Service Bulletin

Bulletin No.: 18-NA-020

Subject: Malfunction Indicator Lamp Illuminated with DTC P0300 and/or P0299/P2227 Set

This Bulletin replaces PIP5511A. Please discard PIP5511A.

5775941

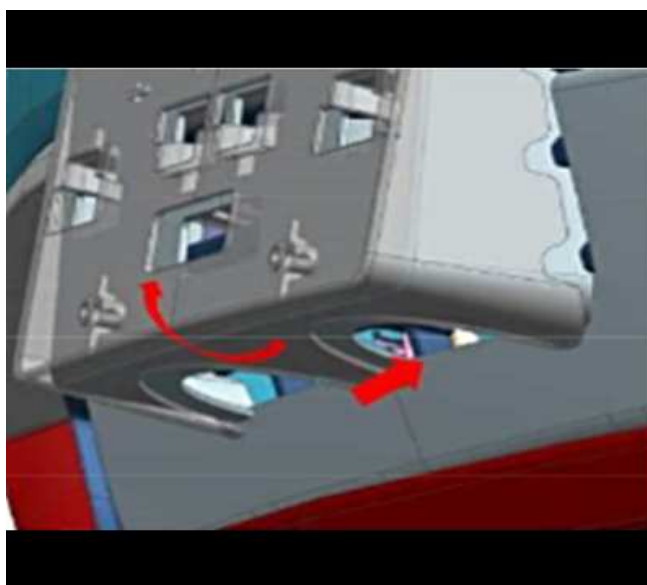
*** For Terrains with front license plate bracket (VK3), install tape over the openings on bottom of the license plate bracket, to prevent airflow from bypassing the grill cover and flowing directly at the charge air cooler, as shown in the picture above.

5736482

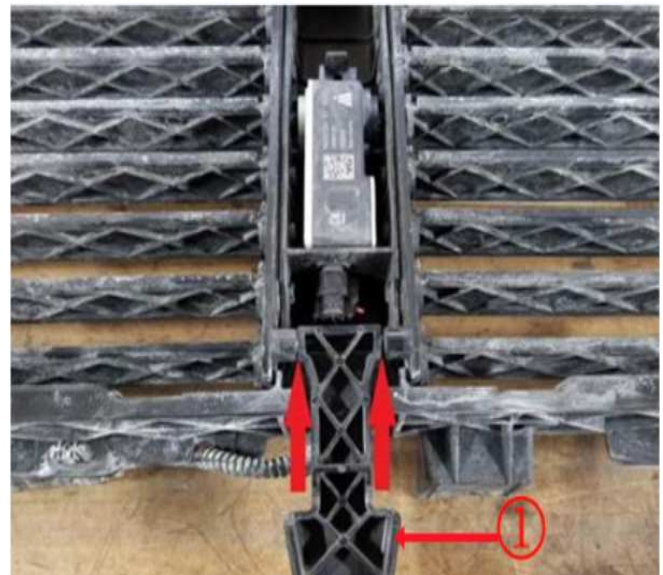
- " Front Bumper Upper Shutter with the Front Bumper Secondary (lower) Shutter attached (1), as shown in the picture above.
- " Front Bumper Lower Shutter that mounts in the front of Charge Air Cooler (2), as shown in the picture above.

5279924

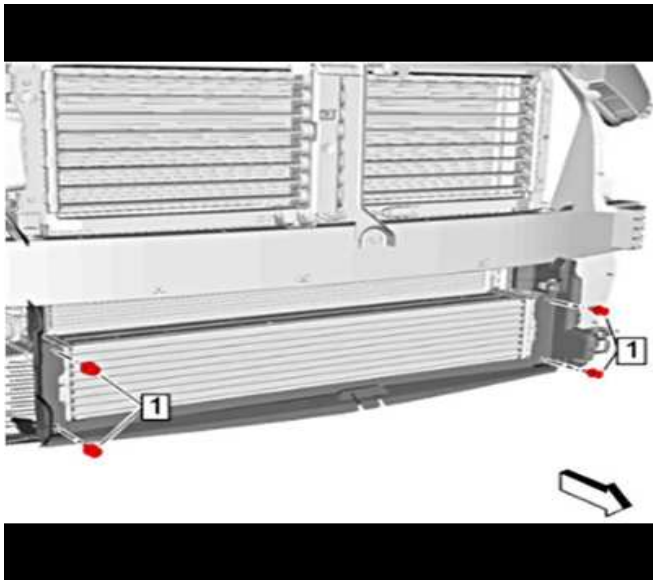
3. On the back of the now removed upper shutter, using a saw blade, cut the upper shutter to secondary (lower) shutter actuator at the pivot location, as shown in the picture above. Remove the linkage (1) and discard.
4. Reinstall the upper shutter.

5775942

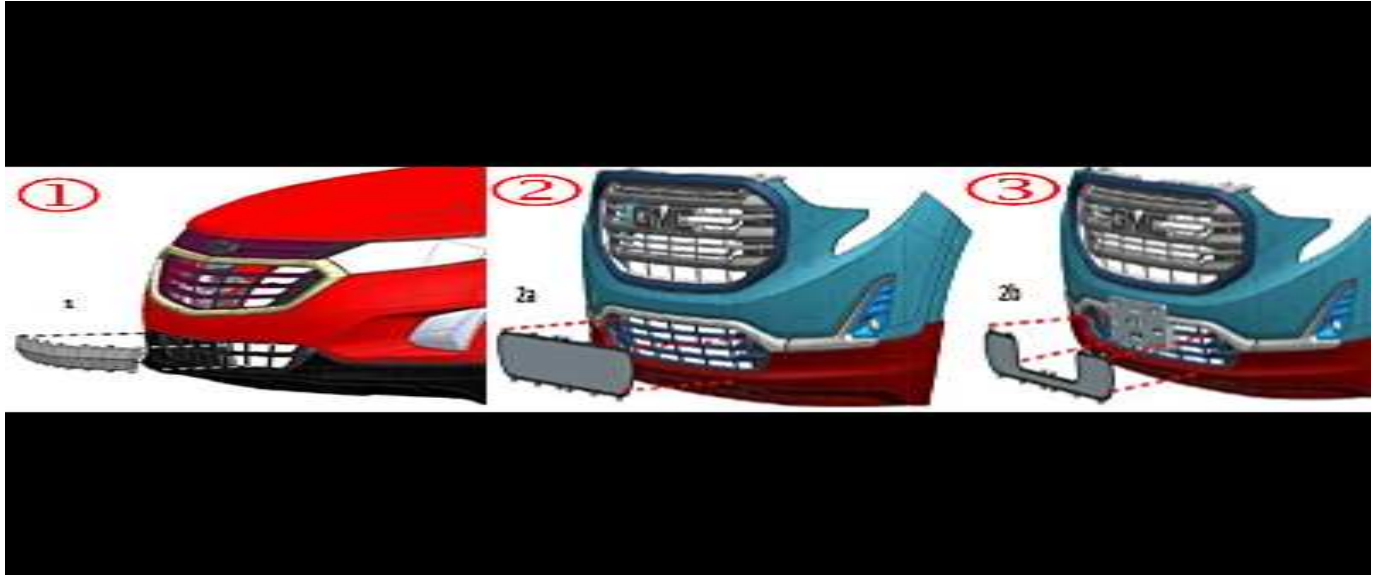
5. Remove and discard the 4 Lower Air Baffle push-in retainers (1), as shown in the picture above.
